UNITED STATES PATENT AND TRADEMARK OFFICE

10/747,617

Office Action Summary	Application No. 10/747,617	Applicant(s) BOOGAARTS ET AL.	
	Examiner Samuel A. Turner	Art Unit 2877

DETAILED ACTION

FIG. 3

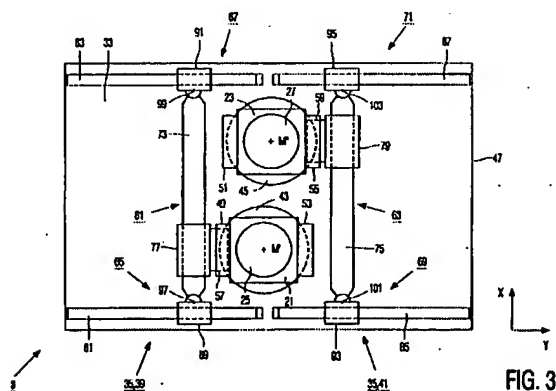
a first exposure system having at least one movable part(figure 3), said at least one movable part being located within said housing, said first exposure system including:

As to claim 4, wherein said additional movable part comprises at least one of a second exposure stage that has at least a movable second substrate holder and a measuring stage for measuring a property of a substrate that has at least one of a movable substrate measuring table and a movable measuring unit(23, figure 3; page 6, lines 8-30).

FIG. 1

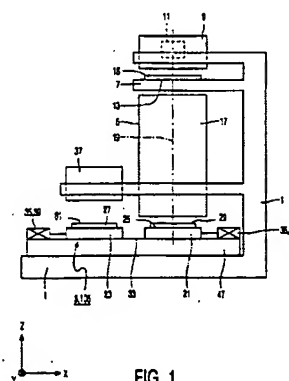
Sato et al teach a precision positioning apparatus for an exposure apparatus including a means for correcting the disturbance of posture or vibration based on the guide mechanism. See figure 1 and column 8, lines 40-63.

FIG. 1

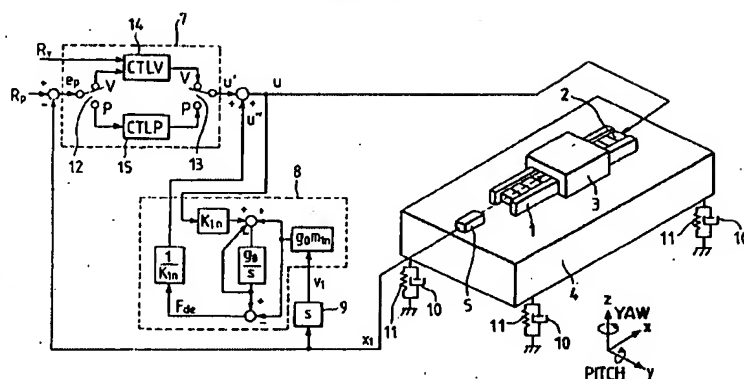
It would have been obvious to one of ordinary skill in the art at the time the invention was made modify the Loopstra apparatus by including the disturbance correction means, taught by Sato et al, into the displacement control unit 35 in order to compensate for posture or vibration of positioning device 3 guide mechanism.

Fig. 1

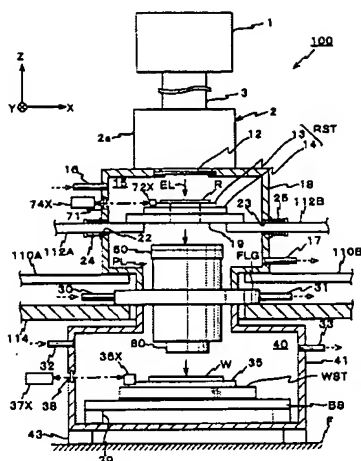
Shiraishi teaches an exposure apparatus in which a partition wall 41 and flange FLG isolate the wafer chamber 40. The wafer chamber includes both optical apertures 38 and 80, as well as gas apertures 32 and 33(paragraph [0095]).

As to claim 16, wherein said second space comprises the environment outside the lithographic projection apparatus(80; paragraph [0107]) or (32,33; paragraph [0095]).

As to claim 17, further comprising a gas transport mechanism configured to transport a flow of gas pass said substrate during projection of the patterned beam onto said substrate, and wherein said position disturbance correction system comprises gas suction mechanism configured to suction gas out of the flow after the flow has passed said substrate(32,33; paragraph [0095]).
